Mountainview Heights 3 (G) - Russell Gardens Building Ltd.

RUSSELL GARDENS
PHASE 4
MOUNTAINVIEW HEIGHTS

VALLEYCREEK 2 ELEV. 3

MAIN LEVEL

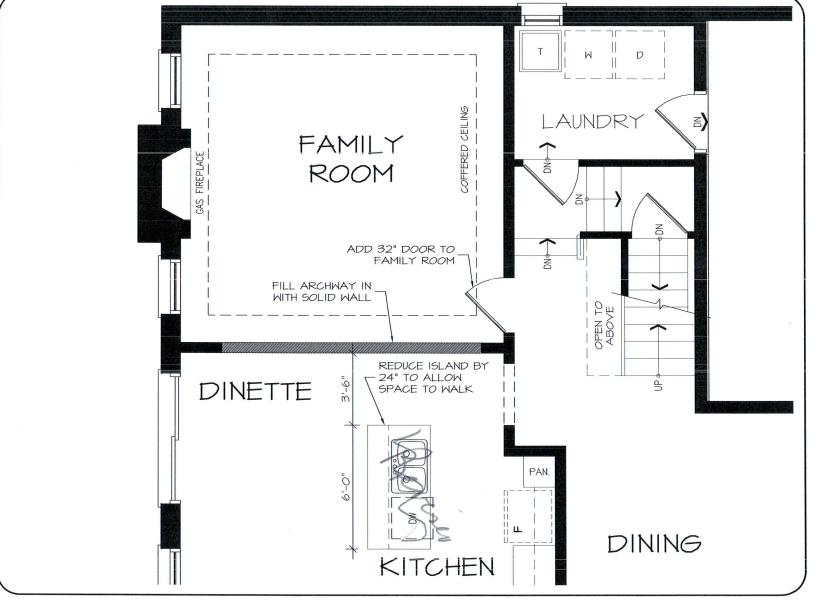
- 1. REPLACE FAMILY ROOM TO DINETTE ARCHWAY WITH SOLID WALL.
- 2. REPLACE FAMILY ROOM TO HALL ARCHWAY WITH 32 INCH DOOR.
- 3. REDUCE KITCHEN ISLAND TO ALLOW TRAVEL SPACE AROUND ISLAND.
